MultiCare  
**EMERGENCY DEPARTMENT & CANCER CENTER EXPANSION**  
TACOMA, WASHINGTON

100% CD SET 9/26/08  
CCD #4 12/17/08

**SEVENTH FLOOR  
PLAN - NORTH  
SYSTEMS**

1 SEVENTH FLOOR PLAN - NORTH - SYSTEMS  
E4.17  
SCALE: AS INDICATED  
0 4 8 16 24  
feet  
as indicated

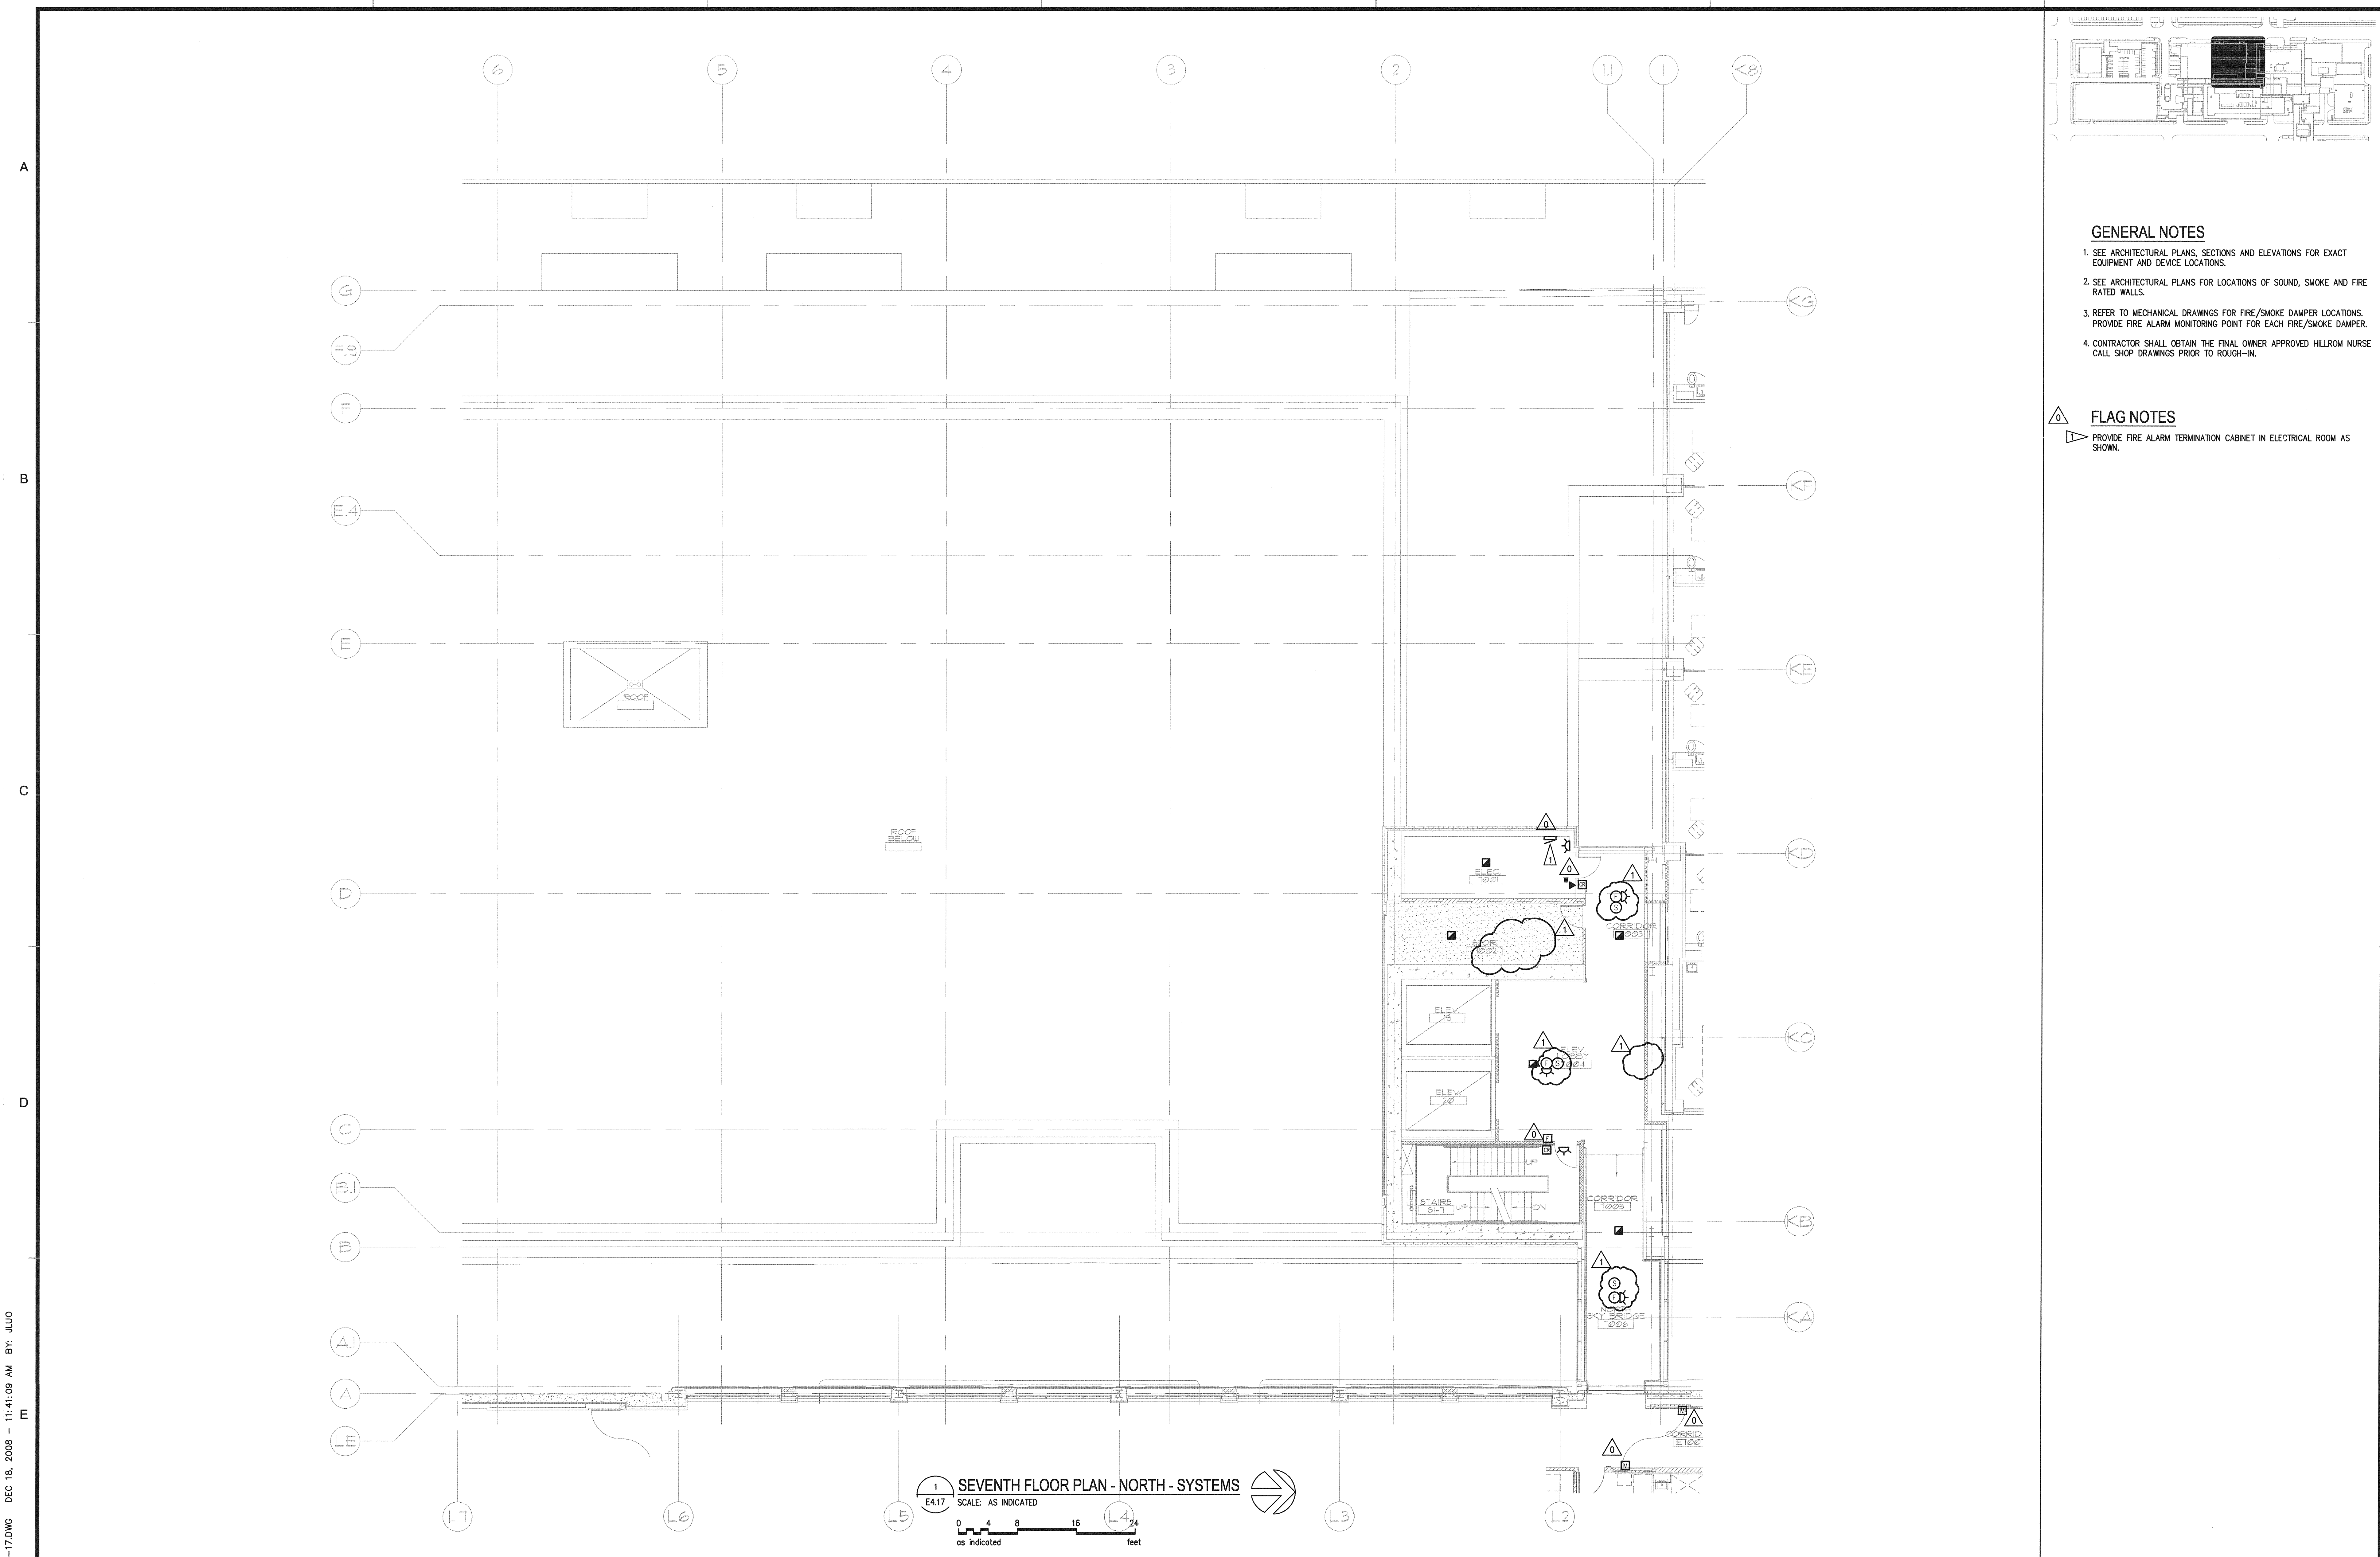
- FLAG NOTES**
- △ PROVIDE FIRE ALARM TERMINATION CABINET IN ELECTRICAL ROOM AS SHOWN.
